| Project | IEEE 802.16 Broadband Wireless Access Working Group < http://ieee802.org/16 > | |
| Title | CTS usage in Synchronized IEEE 802.16h Ad Hoc Networks | |
| Date Submitted | 2005-12-20 | |

Introduction: Given below a recommended changes to IEEE 802.16h-05/027.

Figure A8. Timing of Coexistence Time Slot

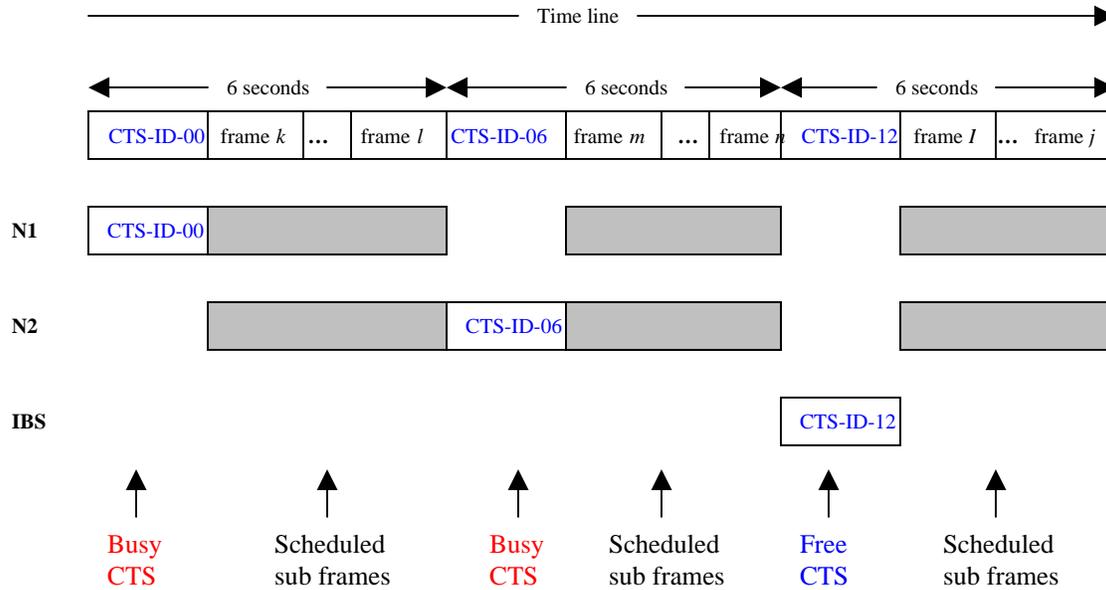
A coexistence time slot (CTS) is a reserved physical frame used for the coexistence protocol signaling purposes. The beginning of the first CTS is at H H:MM:00 UTC, the second CTS is at HH:MM:06 UTC, etc. The beginning of every CTS slot is specified by a UTC message (time stamp). (Figure A8).

Figure 1. Example of OFDM CTS frame structure with TDD

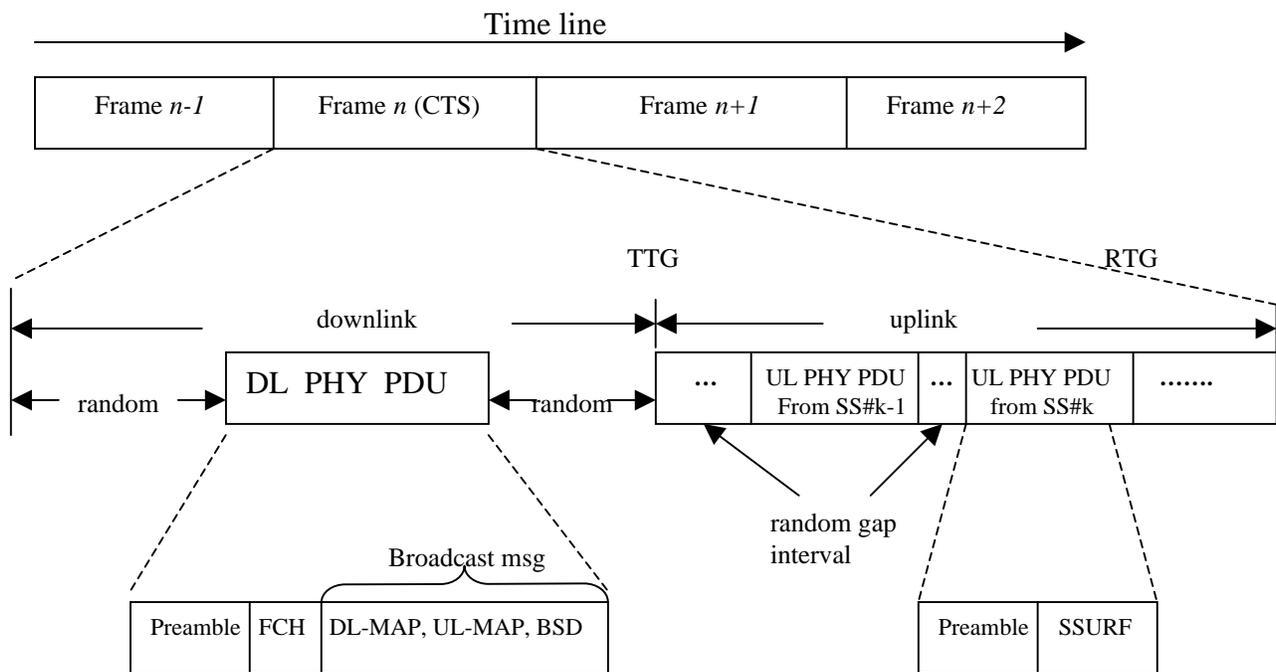
There is only one downlink BSD PDU in the CTS frame and it is transmitted at random starting point within the downlink time interval of the CTS. The rationale for the random placement of the BSD within the downlink subframe is given in Appendix XXX. The CTS frame structure is shown below:
